CONTRACT NO. 10035252

CITY AND COUNTY OF SAN FRANCISCO SAN FRANCISCO PUBLIC WORKS BUREAU OF ENGINEERING			
DESIGNED BY LESLEY WONG 10/2022	CHECKED BY S. HUEY/E.YU 10/2022	DESIGNED BY FERNANDO CISNEROS 10/2022	CHECKED BY M. WONG/E.YU 10/2022
DESIGNED BY LESLAY CHAPPA 10/2022	CHECKED BY D. CHAN 10/2022	APPROVED BY [Signature] 10/2022	
MANAGER, ENGINEERING & CONSTRUCTION BUREAU		ASSISTANT CHIEF ENGINEER WATER & SEWER DIVISION	
CITY AND COUNTY OF SAN FRANCISCO PUBLIC UTILITIES COMMISSION INFRASTRUCTURE DIVISION ENGINEERING MANAGEMENT BUREAU		VARIOUS LOCATIONS PAVEMENT RENOVATION NO. 52 AND SEWER REPLACEMENT MULLEN AVENUE SEWER REPLACEMENT ALABAMA STREET TO PERALTA STREET PLAN, PROFILE AND DETAIL	
SHEET 57 OF 70		DRAWING FILE NO. SW-12	
REVISIONS		REVISION NO. 118,969	
DATE 10/22/2022		REVISION NO. 1

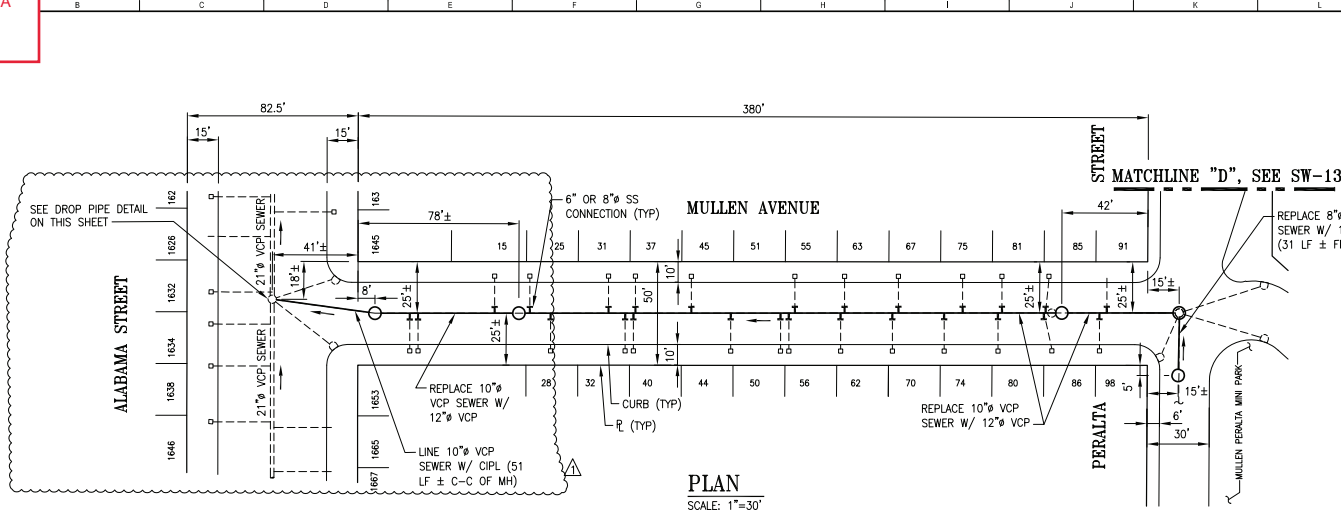
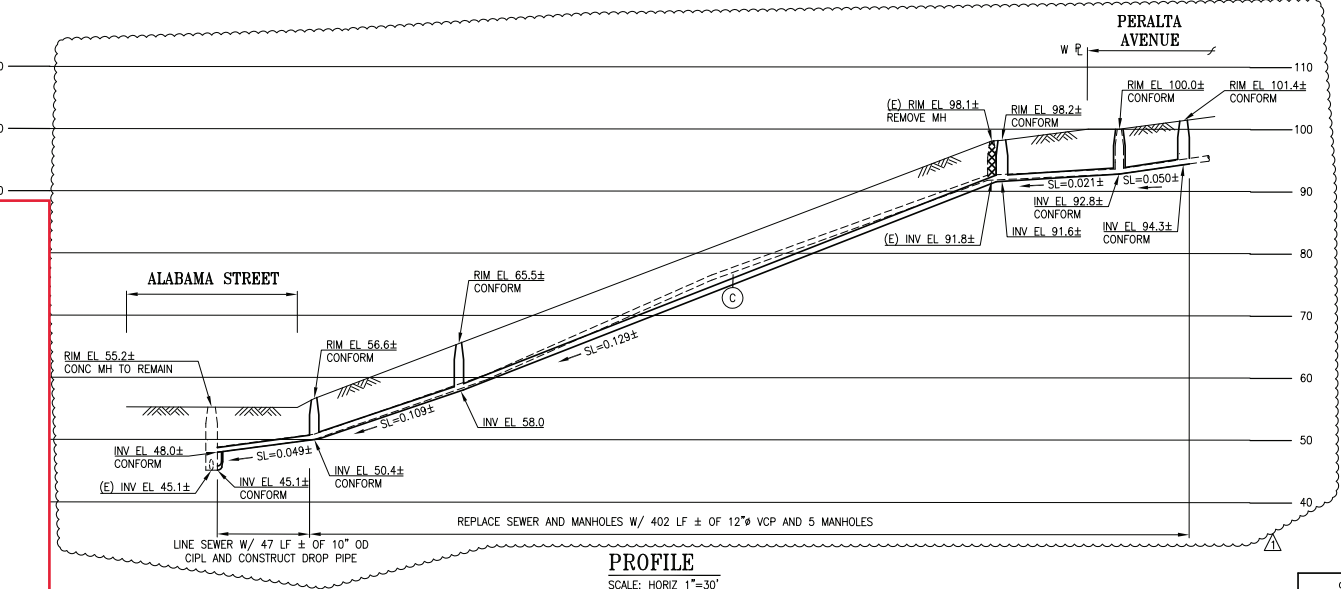
SW-23 - 6" VCP - 253 LF
SW-25 - 10" VCP - 62 LF
SW-29 - Post Videos - 21 EA

6" VCP:
25 - 13 LF
28 - 13 LF
31 - 13 LF
37 - 13 LF
40 - 13 LF
45 - 13.5 LF
50 - 13.5 LF
51 - 13.5 LF
55 - 13.5 LF
56 - 13.5 LF
62 - 13.5 LF
63 - 13 LF
67 - 13 LGF
70 - 13.5 LF
75 - 13 LF
85 - 13 LF
86 - 14.5 LF
91/93 - 13 LF
98 - 14 LF

10" VCP - Mullen & Peralta
N/E Culvert - 41 LF
S/W Culvert - 21 LF
